15 July 2021

1129-1131 PITTWATER ROAD – TRAFFIC RESPONSES TO S.34 CONCILIATION

This letter is written in response to issues raised at the s.34 Conciliation Conference on Friday 25 June 2021 regarding the proposed 1129-1131 Pittwater Road development, submitted for approval by Lotus Project Management (the Applicant). The development application for the site was refused by Council due to (amongst other reasons) concerns about the Right-Of-Way servicing the site.

Figure 1 – Updated management of vehicle conflicts at ground level

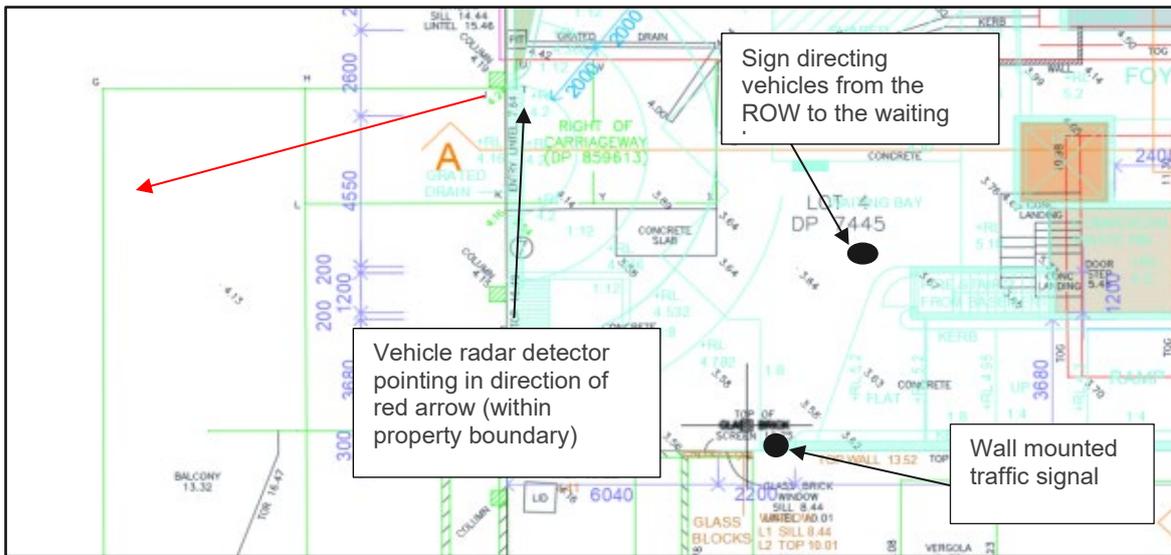
As agreed with Council, a radar based traffic controller would be used to hold vehicles at the top car park ramp to allow vehicles entering the site to clear the Right-of-Way. These vehicles would proceed to the waiting bay while vehicles exited the driveway. Should more than one vehicle enter via the Right-of-Way at any one time, the second vehicle could wait in the service vehicle area.

Figure 1 shows the location of the radar detector and traffic signal, while Figure 2 shows how the signal is controlled. Swept paths for the waiting bay are shown in Appendix A in Figure 3.

Figure 3 – Ground Level B99 Vehicle Sweep Paths

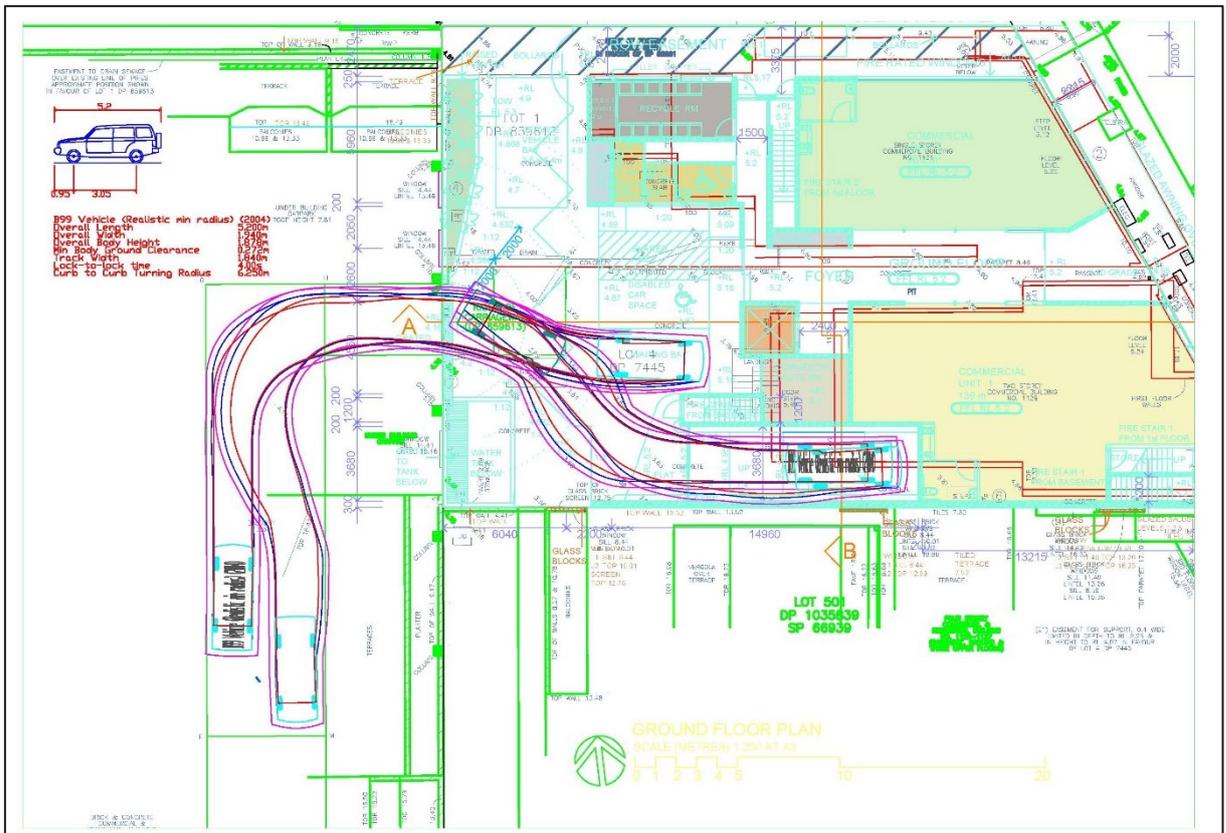
Horizontal swept paths have been updated as per Council's request and are attached. These swept paths show adequate clearances for the B99 Vehicle (5.2 m L x 1.94 m W) as per AS2890.1 Off-Street Car Parking and the small waste service vehicle (6.4 m L x 2.33 m W). These are shown in Appendix A in Figures 3, 4 and 5.

These figures demonstrate that these vehicles accessing the site via the Right-of-Way can stay completely within the Right-of-Way.

Figure 5 – Ground Level Waste Vehicle Swept Path

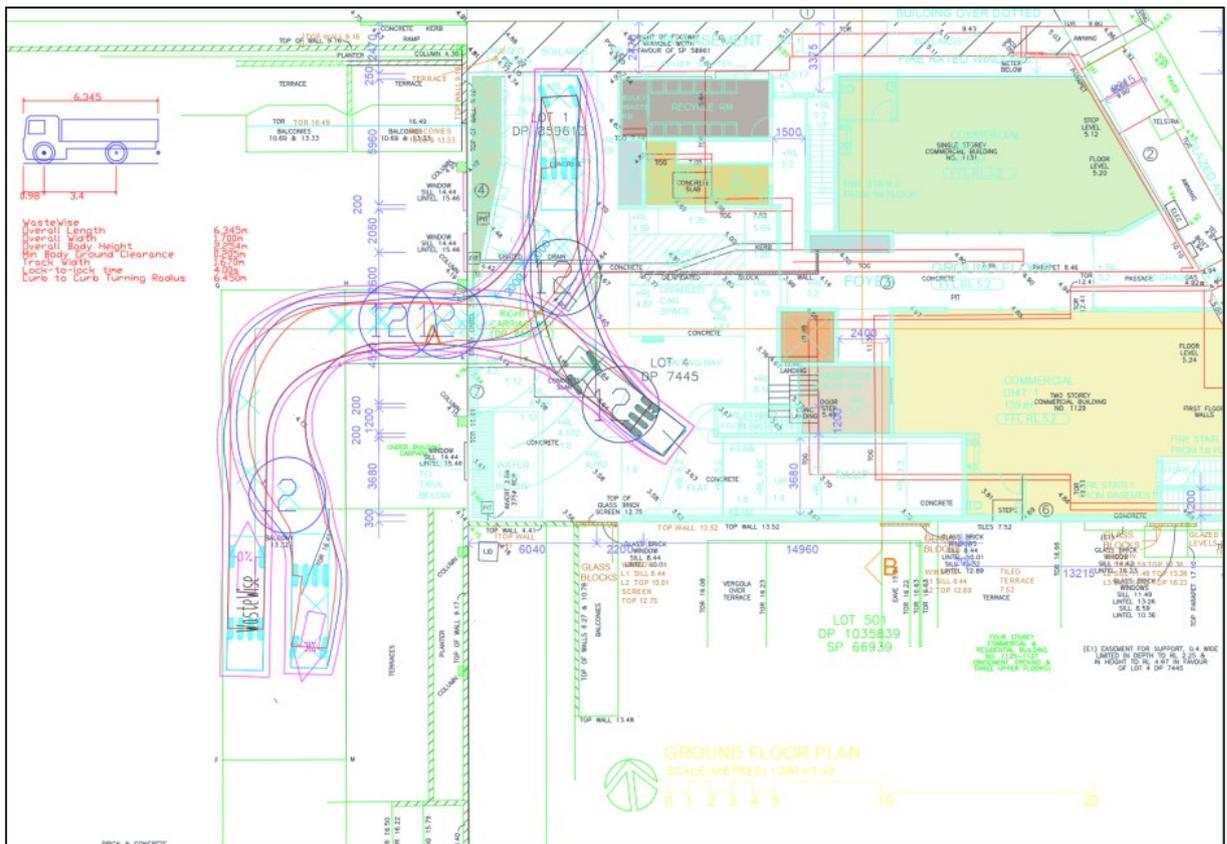
Figure 5 in Appendix A shows clearly that the service vehicle can access the site via while remaining completely within the Right-of-Way.
